# The Proposed Karreebosch Wind Farm and associated infrastructure, Northern and Western Cape Provinces

Motivation for amendment of Environmental  
Authorisation

DEA Ref.: 14/12/16/3/3/2/807

July 2018

**Figure 4.1:** Viewshed analysis representing the potential total visual exposure of the original turbine dimensions (illustrated in green) compared to the proposed new turbine dimensions (illustrated in red).

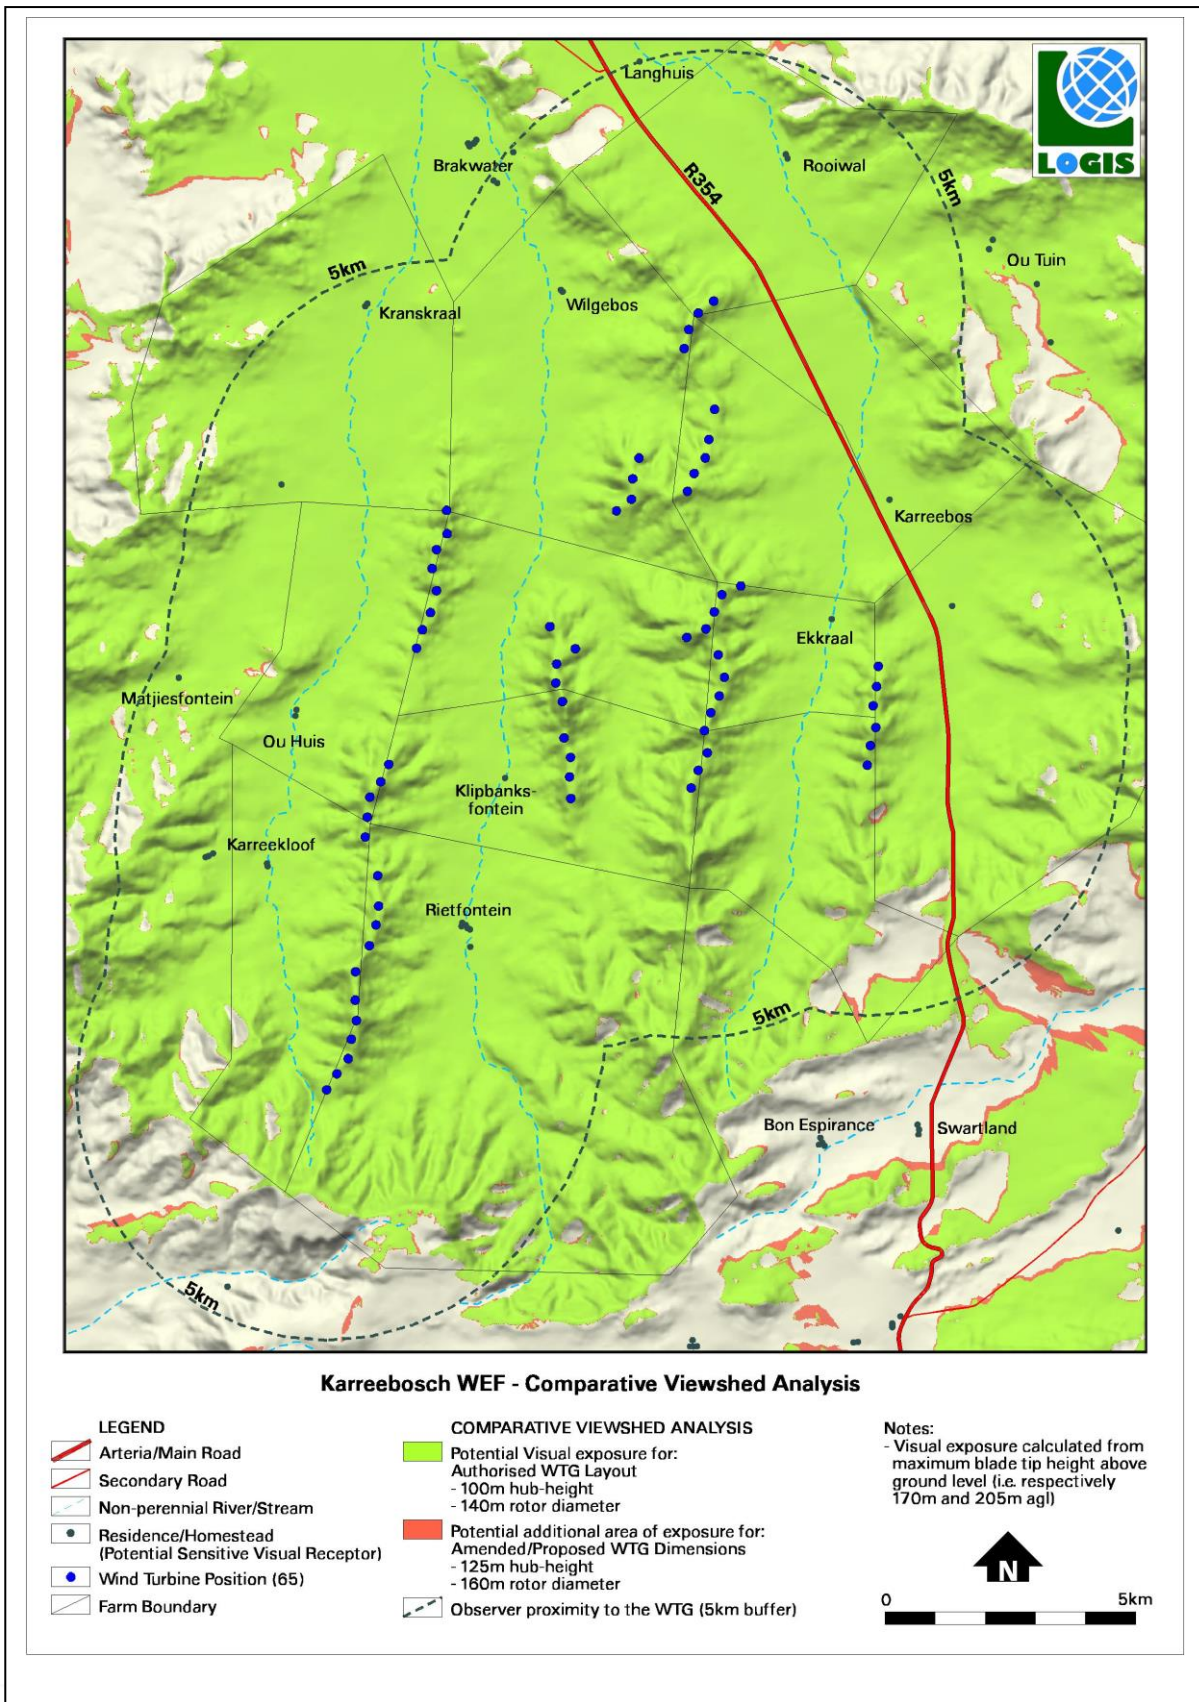
The visibility analysis was undertaken from each of the wind turbine positions (65 in total) at an offset of 170m (maximum blade tip height) above ground level. The result of this analysis represents the potential total visual exposure of the original turbine dimensions (indicated in green). The viewshed analysis was repeated at an offset of 205m to indicate the visual exposure of the increased turbine dimensions (shown in red). The results of the visibility analyses are displayed on **Figure 4.1**.

It is clear that the approximately 17% increase in turbine dimensions would have a relatively small influence on the overall visual exposure, due to the turbine structures previously approved and the elevated positions of the turbines on ridges. The surface area (within the study area) of the original turbine exposure is 435km<sup>2</sup>, compared to the 443km<sup>2</sup> of the increased dimensions of the wind turbine exposure. This is an increase of 7km<sup>2</sup>, or alternatively, an increase of only 1.6% in potential visual exposure. There are no additional sensitive visual receptors located within the area of increased visual exposure.
